AMENDMENT TO THE

WALWORTH COUNTY METROPOLITAN SEWERAGE DISTRICT / ELKHORN SANITARY SEWER SERVICE AREA

RESOLUTION NO. 2007-11

RESPONSE TO REQUEST BY THE WALWORTH COUNTY METROPOLITAN SEWERAGE DISTRICT TO AMEND THE ELKHORN SANITARY SEWER SERVICE AREA

Map 1

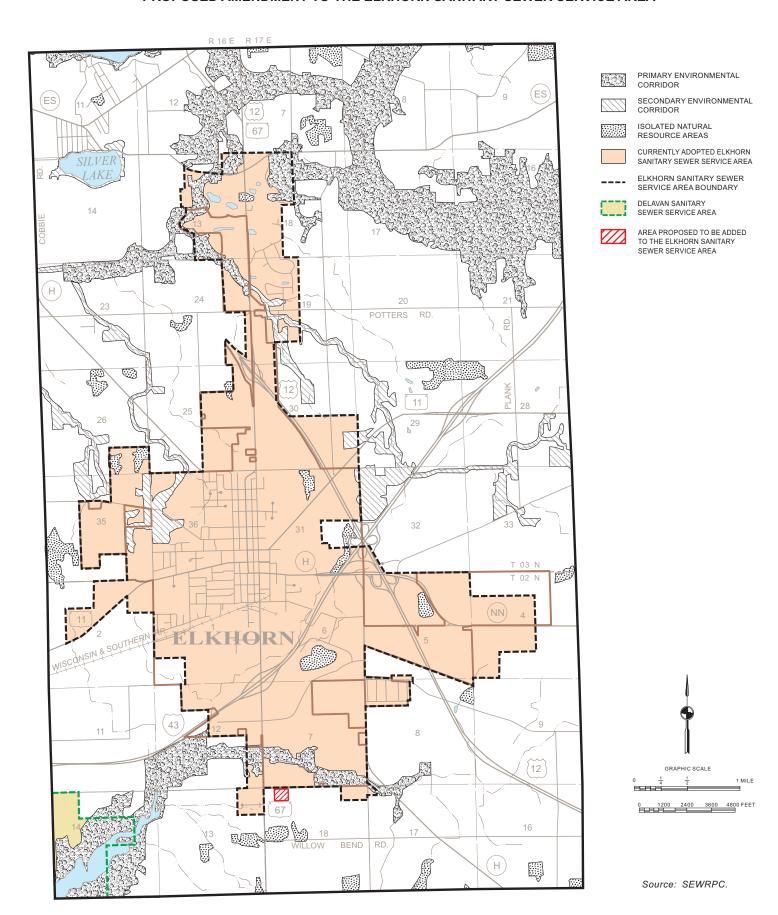
The area proposed to be added to the Elkhorn sanitary sewer service area encompasses 10 acres located about 500 feet east of the intersection of Remer Road and STH 67 in U.S. Public Land survey Section 18, Township 2 North, Range 17 East (see Map 1). All of the subject area is currently in agricultural use, with no environmentally significant lands present. The subject area is anticipated to be developed for institutional use as a church. There would be no change to the resident population of the sewer service area.

Based upon the foregoing, it is recommended that the Southeastern Wisconsin Regional Planning Commission formally amend the sanitary sewer service area plan for the Elkhorn area as documented in SEWRPC Community Assistance Planning Report No. 56 (2nd Edition), as amended, in the manner identified on Map 1. A more detailed delineation of the revised sewer service area and the environmentally significant lands within is shown on an aerial photograph reproduced as Map 2.

Map 2

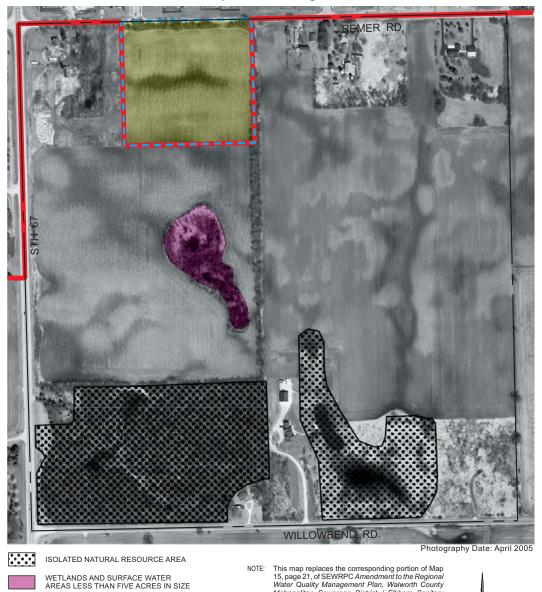
NOTE: This map replaces the corresponding portion of Map 15, page 21, of SEWRPC Amendment to the Regional Water Quality Management Plan, Walworth County Metropolitan Sewerage District / Elkhorn Sanitary Sewer Service Area
